ADDENDUM No. 1

RFP No. 999

Scalehouse Management Software

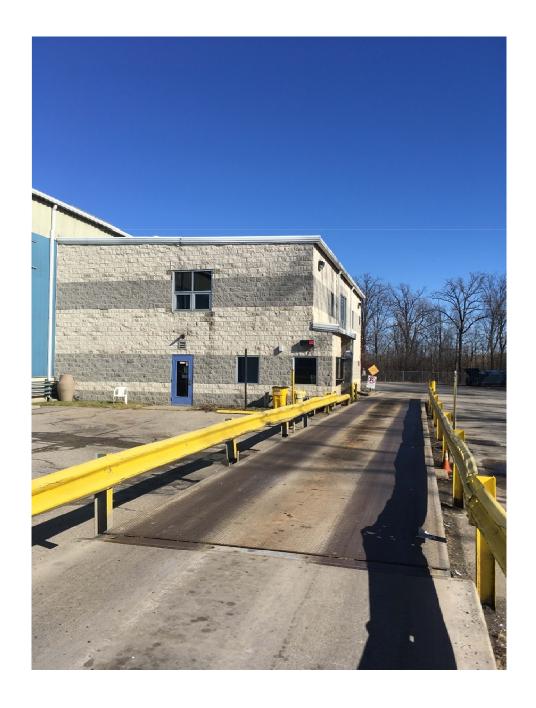
Question 21: Can the city provide a diagram and pictures of the Scalehouse at the MRF? Response 21:
